Annex A

*Scheme Clarifications - Technical Clarifications about the major differences
between the PAS and the Present Scheme*

SUPPLEMENTARY CLARIFICATIONS FOR A/SK-TLS/64

Figure F7

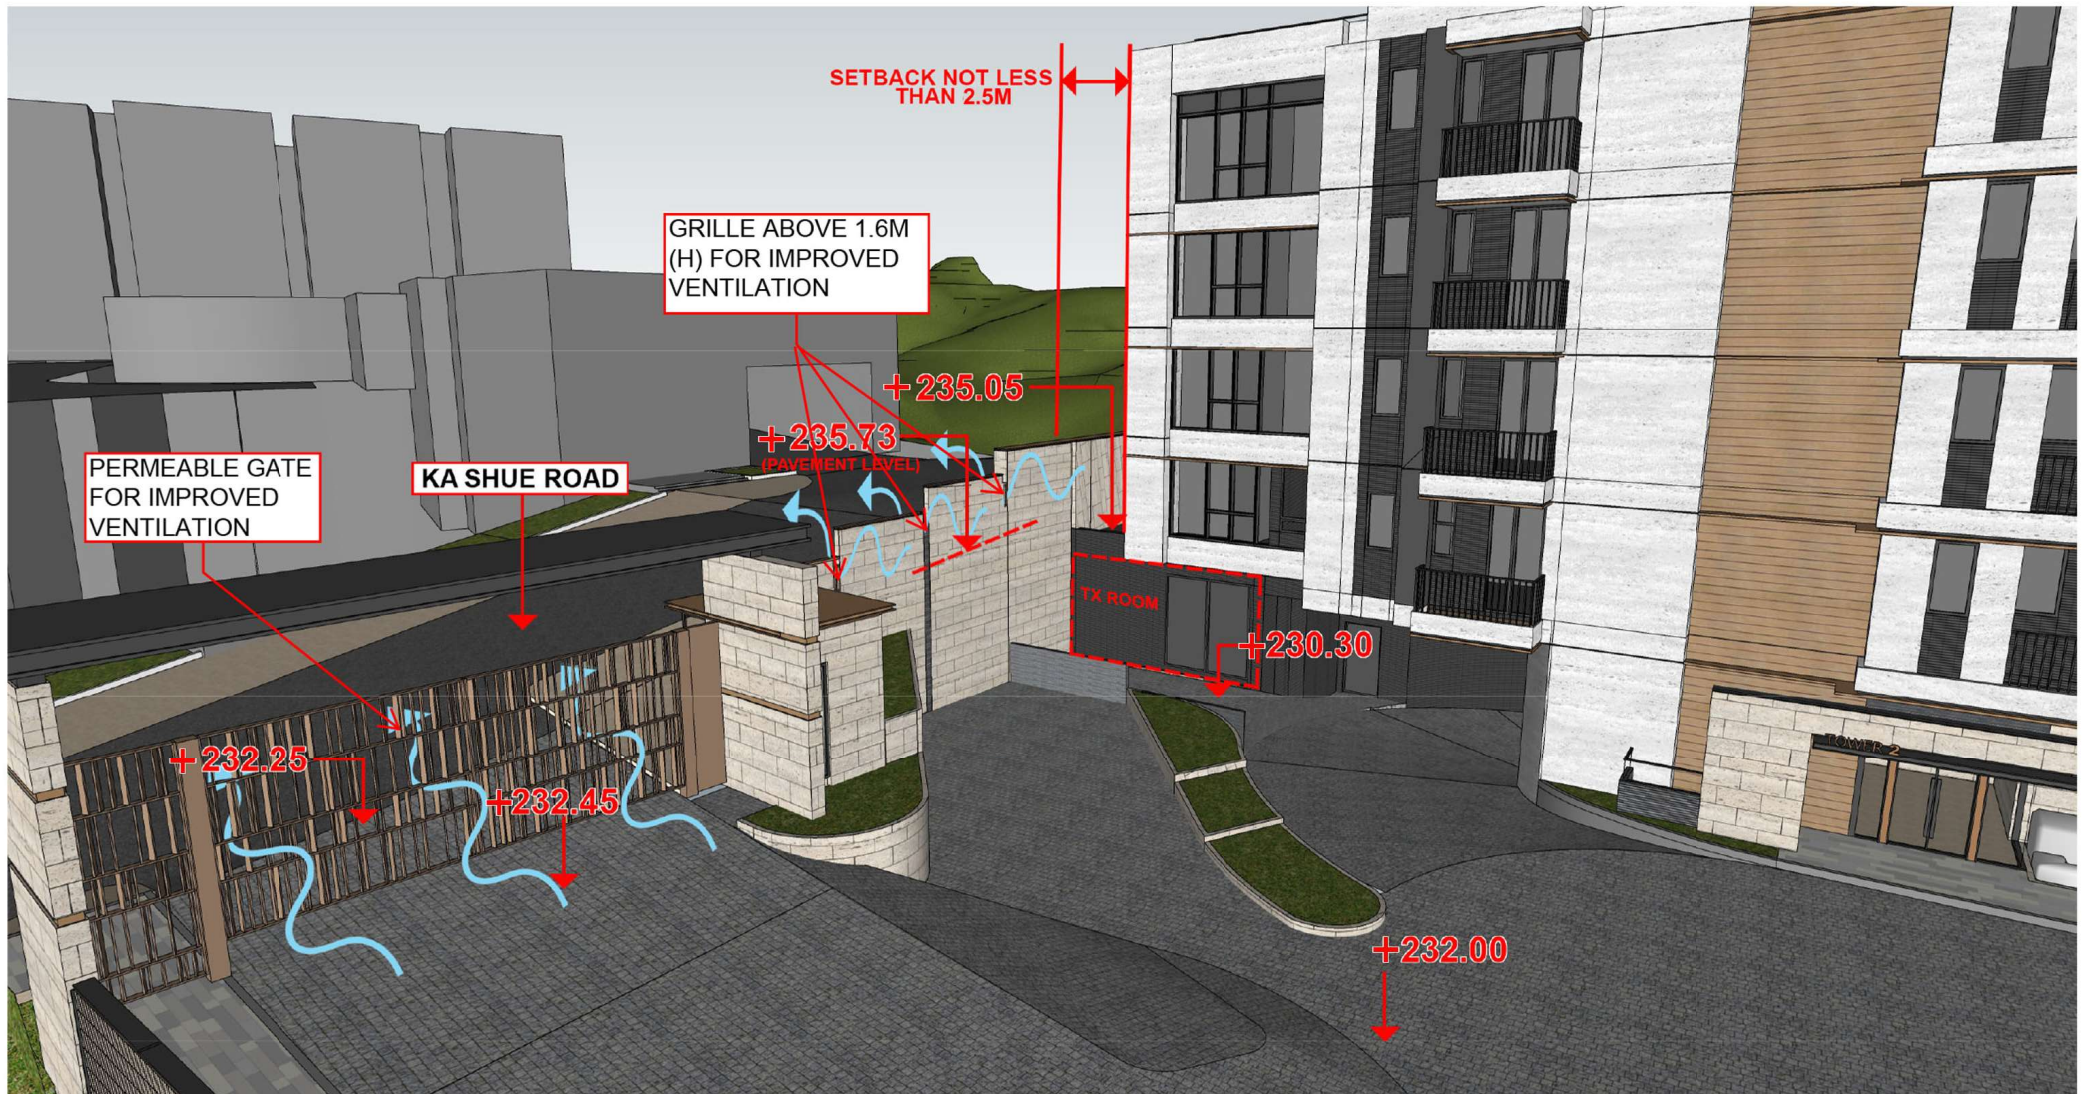
C.4. To further enhance the natural wind penetration onto Ka Shue Road without jeopardizing the privacy of the on-site residential units with windows fronting Ka Shue Road, the upper portion of joining areas between boundary wall partitions (i.e. portion above 1.6m measured from ground level) will be in the form of grille, as shown in **Figure F7**.

Figure F10

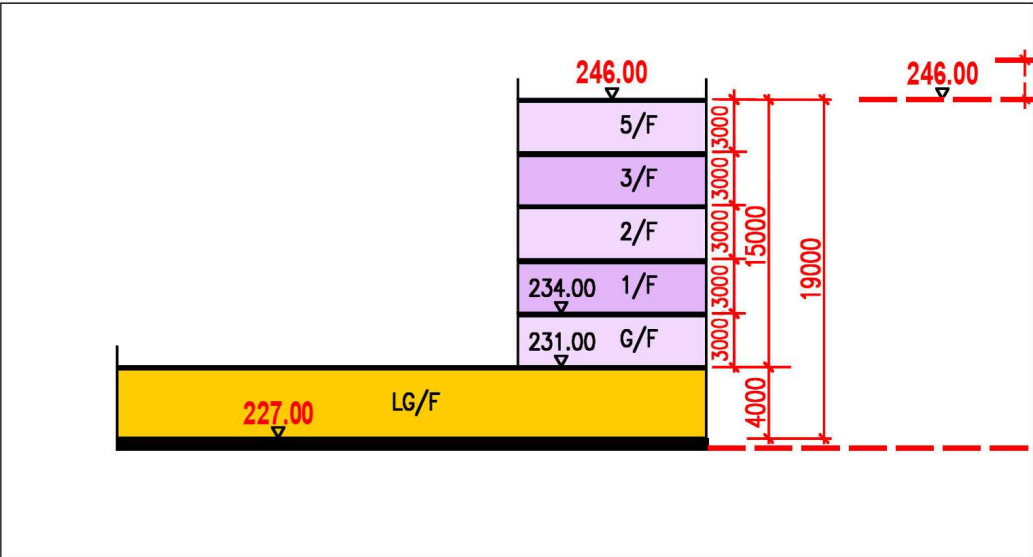
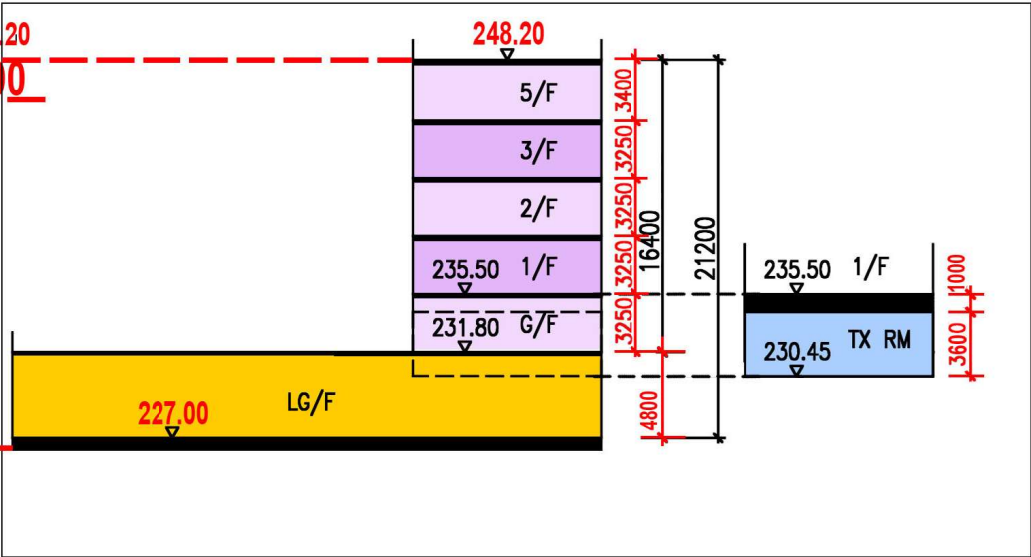
D.5. **Figure F10** compares the BHs proposed in the PAS and the present scheme. The resultant overall maximum BH at the main roof level in the present scheme is 21.2m (**Figure F10**). With the re-arrangement of the new site formation levels, the absolute BHs proposed in T1 and T2 in the present scheme are both 21.2m.

D.6. **Figure F10** compares the BH proposed in the PAS and the present scheme for easy reference. The proposed BH in the present scheme represents only an increase of 2.2m when compared to that in the PAS [i.e. 0.8m (for LG/F) + (0.25m x 4 from G/F – 3/F) + 0.4m (5/F)]. This is considered minor in nature.

Due To Technical Difficulties 1 , 2 & 3 On Transformer Room ,
Together With Proposed Relaxation Of Heights ,
Current Submission Proposes Total Increase
Of 2.2M In Overall Building Height

Total Increase
In Overall
Building Height
 $= 0.8 + (0.25 \times 4) + 0.4 = 2.2\text{M}$

Figure F11

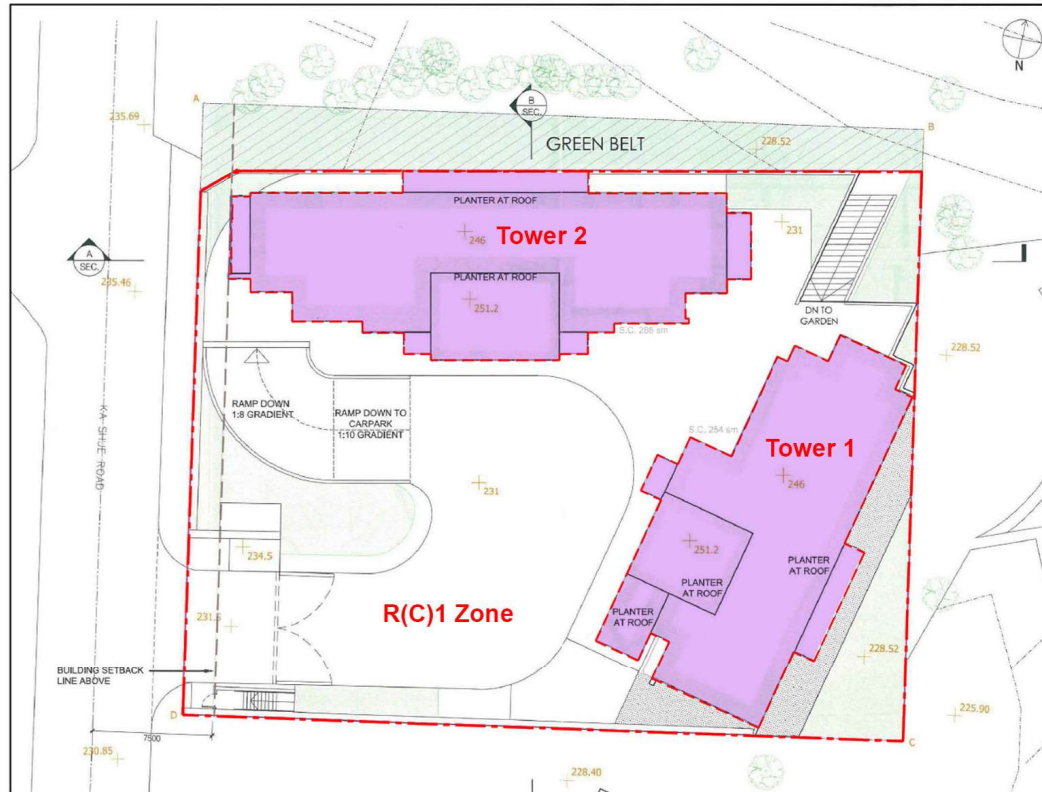
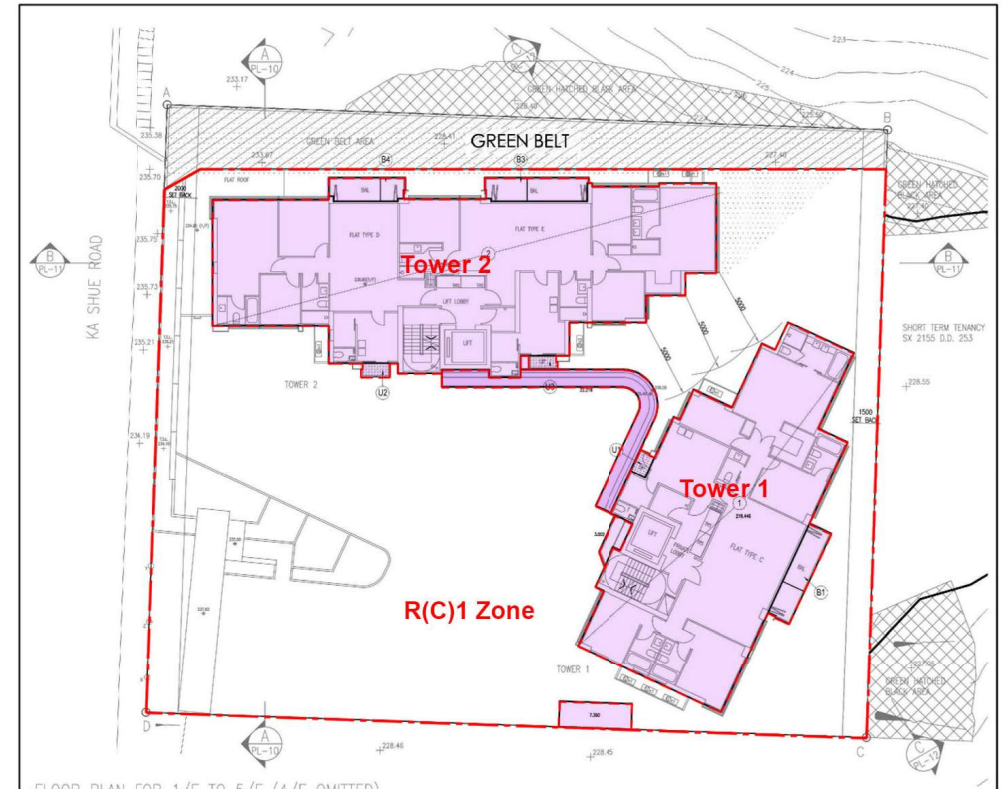
- E.4. In the present scheme, the Project Team has made its best effort to cut down the overall site coverage to a bare minimum of about 34% within the extent of the “R(C)1” area. **Figure F11** compares the site coverage calculation between the PAS and that in the present revised scheme. Compared to that in the PAS, they are almost the same (i.e. 33.911% in the PAS vs 34% in the present scheme).

Proposed Slight Increase in Domestic Site Coverage By 0.123% To Provide Users' Friendly Pedestrian Connectivity with Cover Between Tower 1 And Tower 2, So As To Improve the On-Site Well-Being / Livelihood of The Development. (BEAM PLUS)
